DA0425/2016

**Representation – 82-90 Balfour Street, Launceston – DA0425/2016**

## Representation for 82-90 Balfour Street, Launceston (DA0425/2016)

**Figure 1** – Alternate ground floor footprint that can also be applied to level 1 to achieve a reduced dwelling height while maintaining total floor area.

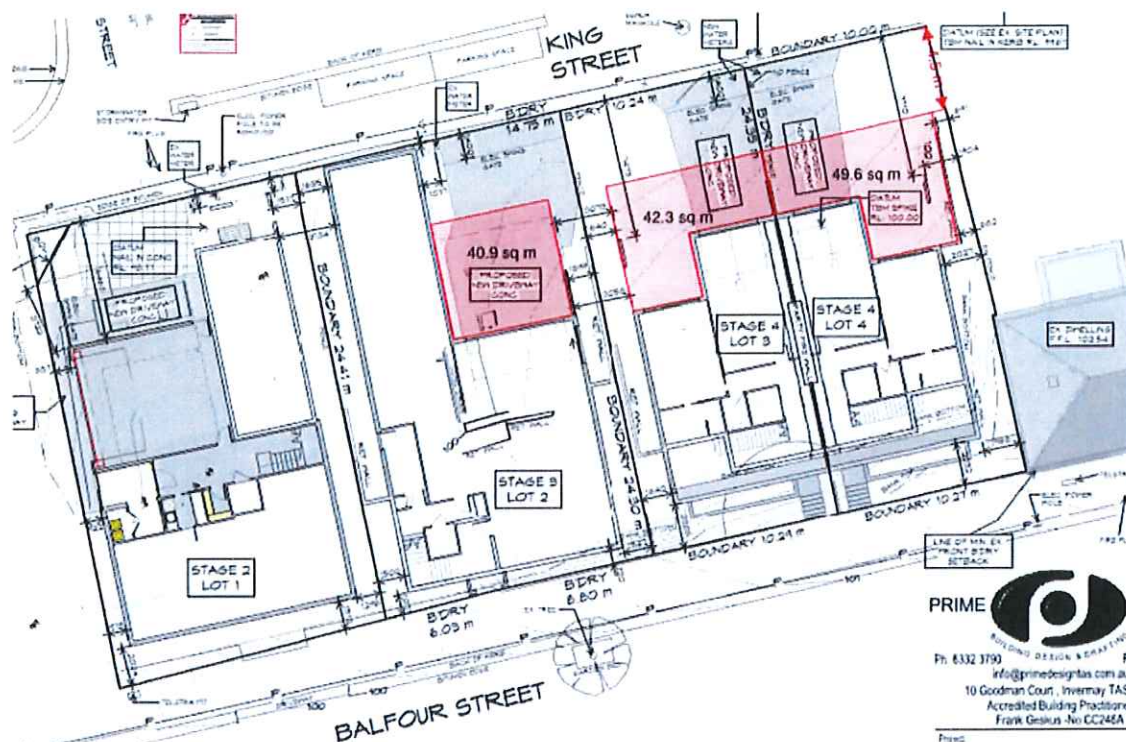
As an alternative to the out-of-context 3 storey forms, the applicant could have considered utilising more of the site to achieve the same floor area rather than increasing the height to exceed the Building Envelope provisions. In doing so, also achieving a reduced building height which is more in keeping with the existing adjacent single and double storey dwellings. We have attempted to

demonstrate this in Figure 1. It is noted that this would flag further discretion against this provision; however we believe this would be a more sympathetic outcome.

**Figure 2 – King Street (Northern Streetscape) heights assuming heights are correct from ground level shown.**

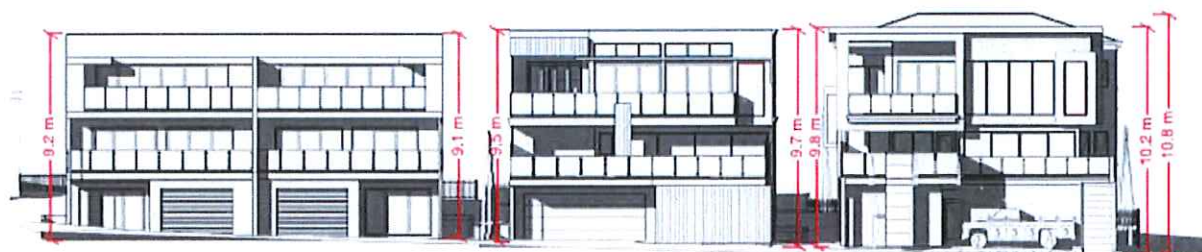
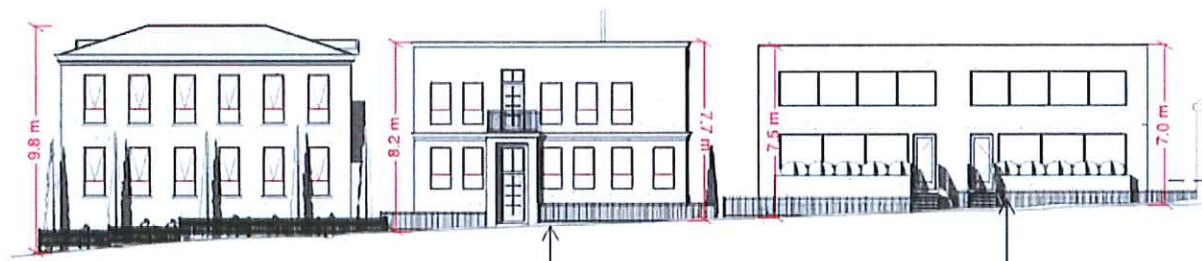
It is considered that the height and bulk of the proposed dwelling buildings are not sympathetic to character set and established by the existing residences located to the north (King Street – Figure 2) and south (Balfour Street – Figure 3) of the subject site. The applicant does not provide sufficient justification to the heights proposed for all dwellings.

It is our view that further consideration should be made to reduce and minimise the visual bulk and height within the streetscapes –Balfour and King Streets.
